Product Improvement Announcement

New Metal Receptacle Casing for DS100, DR150, DSN150, and DSDC9

Issue date: 4 August 2021

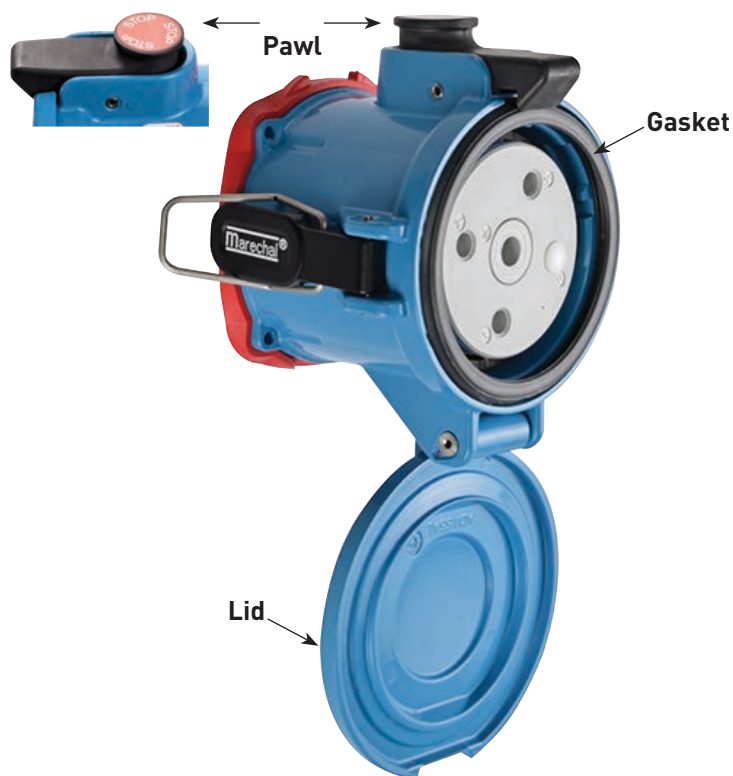
Effective August 9th, 2021, the DS100, DR150, DSN150, and the DSDC9 will be supplied with a new, improved metal receptacle casing. This change elevates the design of the casing so that it is similar in appearance and performance to other MELTRIC product lines.

- New Robust Material. The metal casing is now made of injected Aluminum for improved impact resistance.
- Red dot indicator mark has been added on the receptacle casing and inlet for easy accurate connection.
- A silicone double-lipped gasket is now assembled in the receptacle casing as opposed to the receptacle lid. This allows for Type 4X, IP69 watertightness when the receptacle casing lid is closed and/or the inlet/receptacle is connected.
- The lid now opens at a 180° angle as standard instead of the previous casing lid which only opened at a 90° angle. The option for a 180° angle is no longer necessary and has been removed.
- The new pawl is now larger and more robust with the addition of a red “stop” label.
